**COLORADO**  
Oil & Gas Conservation  
Commission  
Department of Natural Resources

Inspection Photos: Laramie Gunderson Loc#449070

Photo#1:

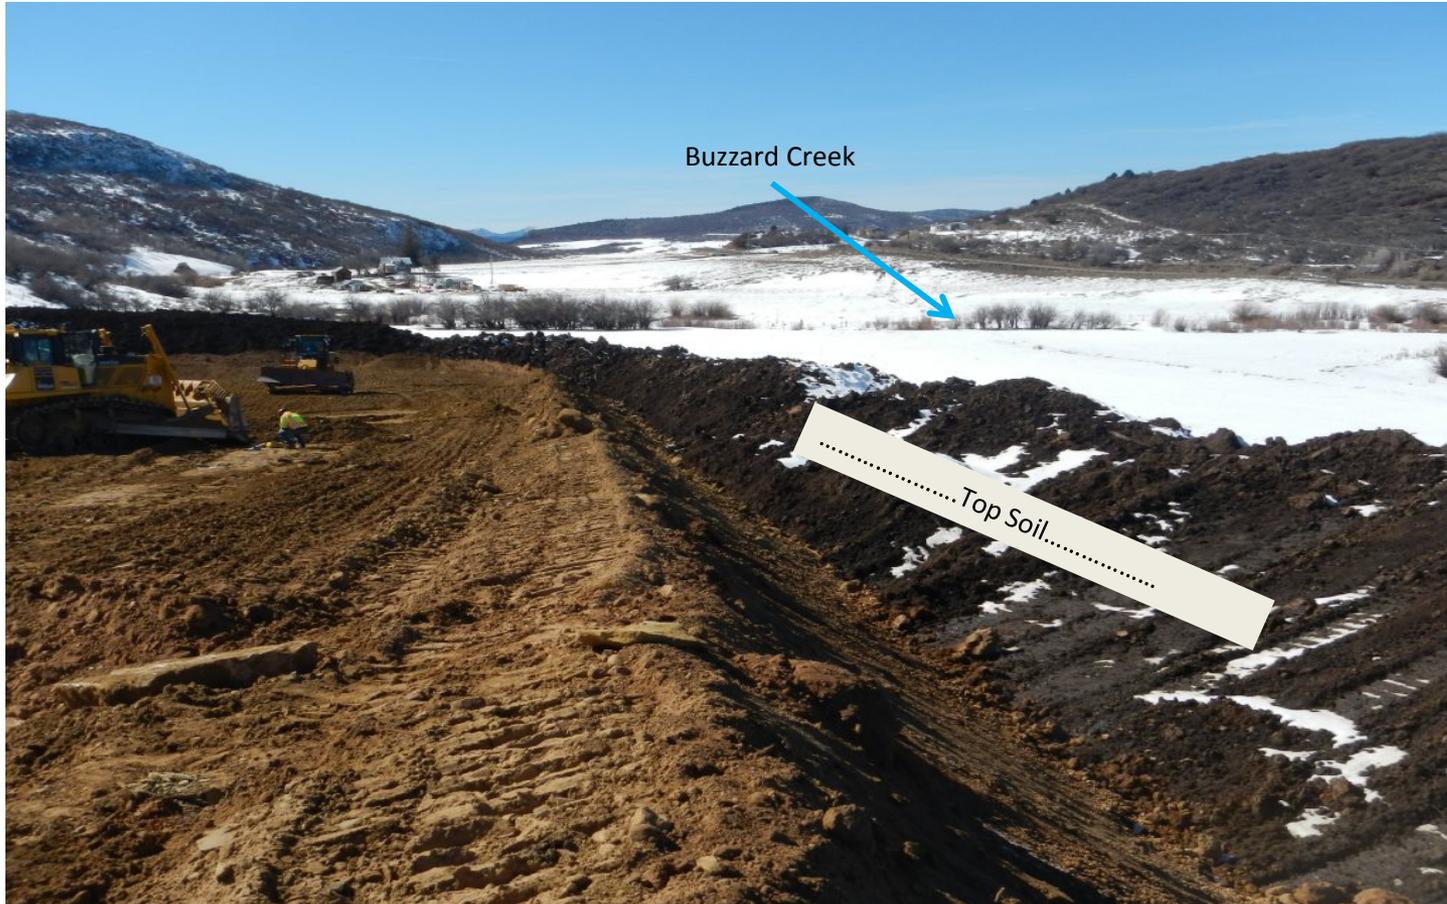
View of Location From 330 E Rd to SE. Red dotted lines indicate Top soil salvaged & stored around Location Perimeter. BMPs have not been installed along outside base of Soil piles to prevent Run-off / Sediment Migration to nearby surface water or any drainages leading to surface water. North Perimeter is of most Concern
